NEBRASKA CAPITOL ENVIRONS COMMISSION

AGENDA

August 27, 2021

- 2. Exterior Improvements at 1320 Lincoln Mall (Sinclaire Hille; *UDR21068*)
- 3. Outdoor Nature Classroom at 1843 K Street (Community Action *Partnership; UDR21069*)

1320 LINCOLN MALL BUILDING EXTERIOR ELEVATION - SOUTH

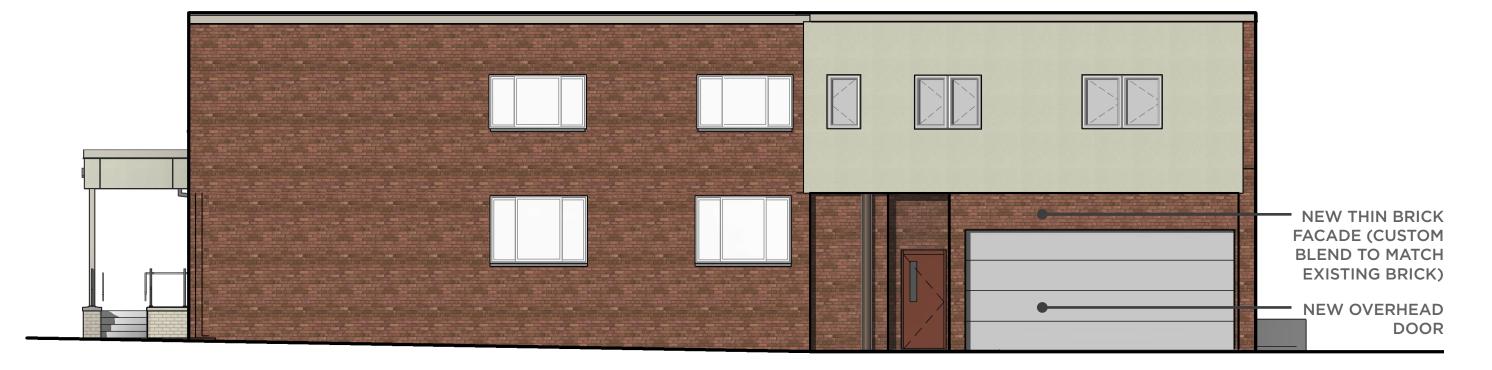
Overall, the proposed exterior improvement for 1320 Lincoln Mall enhance the quality of the building's architecture and fit within the context of Lincoln Mall as much as can be expected for an existing structure.

The above rendering shows the proposed improvements to the south façade for 1320 Lincoln Mall, including signage, metal coping along the roofline, new and expanded windows, an entry canopy structure, and a new ramp/stair system with a masonry veneer.

| Recommended Finding: | The exterior improvements being proposed at 1320 Lincoln Mall are consistent with the Capitol Environs Design Standards. |

Approval of a Certificate of Appropriateness for exterior improvements at 1320 Lincoln Mall.

1320 LINCOLN MALL BUILDING EXTERIOR PERSPECTIVE - SOUTHEAST

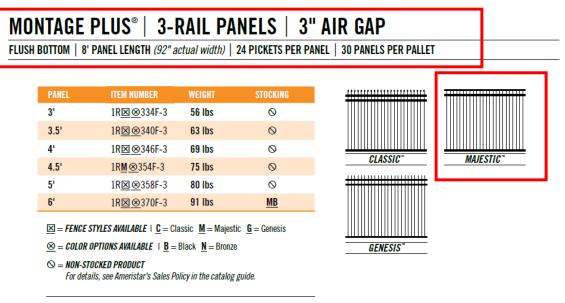
The rendering above highlights the new overhead door being added at the northeast corner of the 1320 Lincoln Mall building.

MONTAGE PLUS®

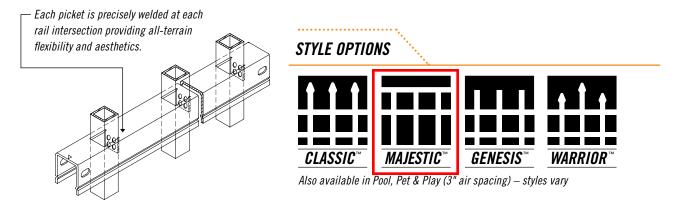
While this guideline does not specifically mention fences, its focus on durable materials and neutral colors should serve as the framework for judging this proposal. The proposed fence is a reasonably durable, neutral-toned product designed specifically for applications where child safety is desired.

In addition to the Capitol Environs Design Standards, a childhood care facility like this is also required to follow its own specific set of design standards (Chapter 3.90 Design Standards for Early Childhood Care Facilities), and those standards suggest that an opaque fence be provided around the perimeter of outdoor play areas when the playground is adjacent to a residential use. There are residential properties to the east and south of the proposed play area, but in both cases, a parking lot sits between the play area and the residential. Therefore, it is staff's view that this scenario does not require a fully opaque fence and that the style being proposed would suffice. However, it is well within the Commission's purview to weigh in on these additional standards (shown below) and offer direction and guidance.

The proposed outdoor nature classroom east of the building at 1821/1843 K Street sign is consistent with the Capitol Environs Design Standards. Recommended Action:

Approval of a Certificate of Appropriateness for an outdoor nature classroom at 1821/1843 K Street.
